# ULPOWER AERO ENGINES N.V.

## SERVICE BULLETIN

Service Bulletin No. 2017-01

SUBJECT: installation guideline for oil coolers

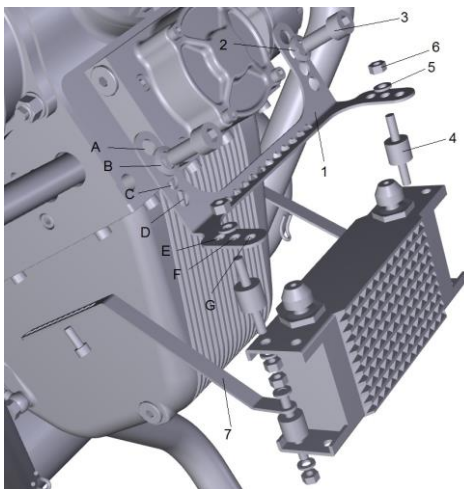
Recently our supplier changed the installation guidelines for the oil coolers with ULPower part numbers E0426107 – E0426110 – E0426113 – SE0426205 – SE0426116.

Consequently, we changed the guidelines in our installation manuals.

Please install 4 shock absorbers as shown on the drawing below. (part n° 4).

Even if you have installed our oil coolers in another way, make sure to insert shock absorbers.

Article number: F2662015 X4 3.5 EUR /pc

If you prefer to buy them at a local store, look for a shock absorber of 15mm with M6
